601 W Cordova St (PRELIMINARY APPLICATION)
DP-2025-00916 – DD (Area B)

DEVELOPMENT PERMIT STAFF COMMITTEE MEMBERS

DEVELOPMENT PERMIT STAFF COMMITTEE RECOMMENDATION: APPROVE

Figure 5: Proposed extent of encroachment (red area) above future SRW

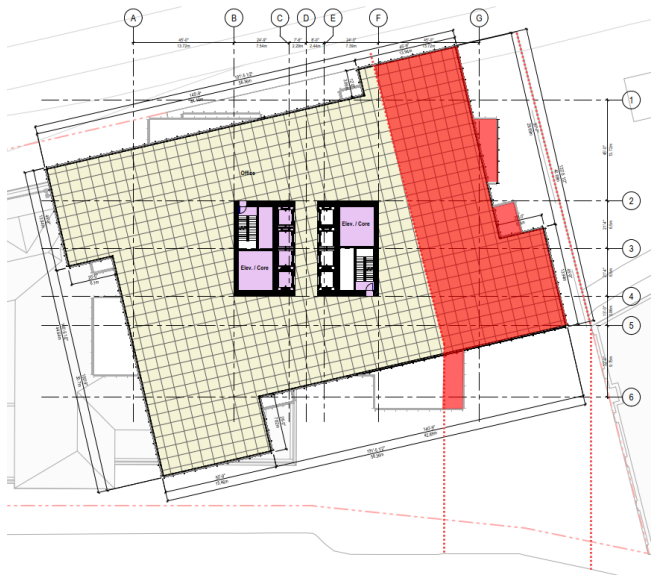
In particular, the proposed overhang of the upper floors that stagger out over the future roadway will cause a partial obstruction of sky views and natural light, affecting pedestrian amenity (see Appendix L for SRW encroachment illustration). The overhanging levels represent about 17% of the proposed floor area above grade.

However, the application also compromises the openness and amenity of the Cordova Connector and reduces the Seymour Street view with the proposed overhanging structures (see *Figure 5*).

Staff recommend removal of these overhangs in condition of approval 1.2.

Figure 6: Framework plan showing Cordova Connector

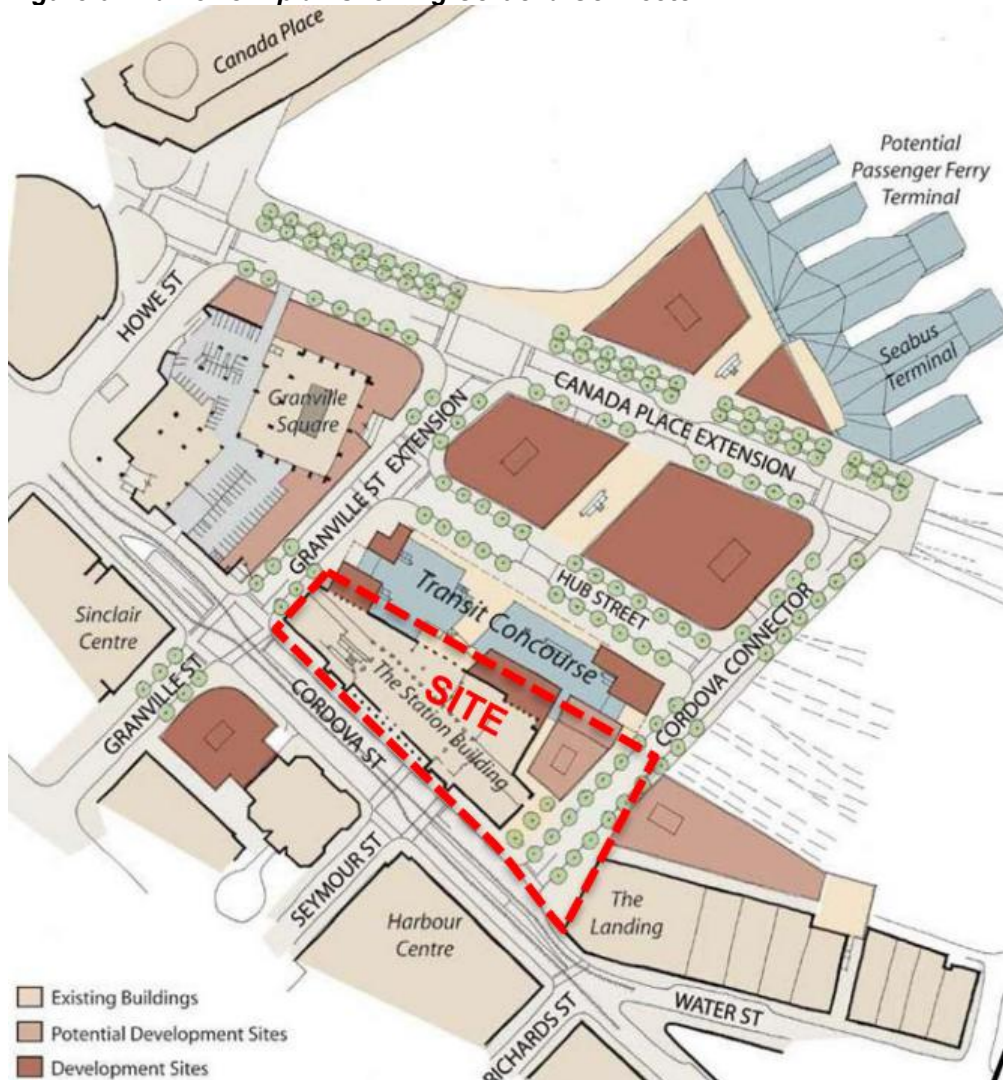
The application supports a key Framework goal by providing open space at the W Cordova Street level to allow for the planned Cordova Connector. This open space is intended to be secured by a future Statutory Right of Way on the property.
